McLaren Artura - Oil Tank Replacement

Bulletin type:	Service Campaign
Reference number:	N/A
Campaign reference:	SCB 16 F 002
Attention:	Retailer Aftersales Managers, Retailer Service Managers, Retailer Service Advisors, Retailer Technicians, Retailer Parts Managers
Affected vehicles:	McLaren Artura
Situation:	Oil tank replacement
Procedure:	Action affected vehicles during next Retailer visit. Please refer to the information outlined in this document to complete the required work
Date:	07 December 2023

Image 1 Oil Tank location

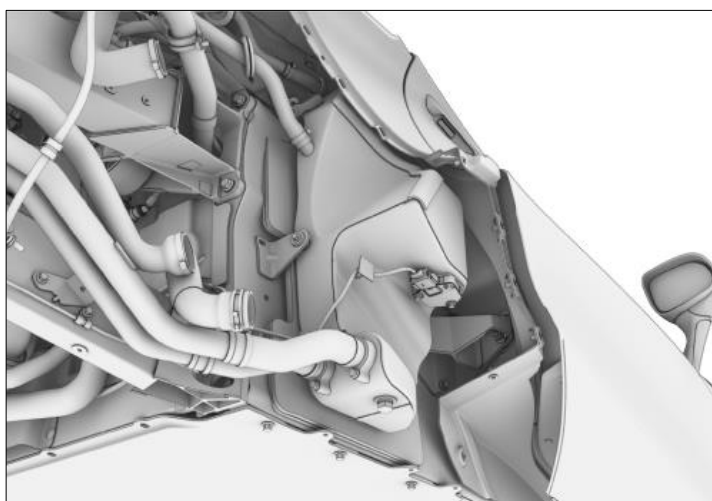
Through continuous product quality monitoring, McLaren Automotive has updated the specification of the engine oil tank. This document outlines the details for the replacement of the oil tank.
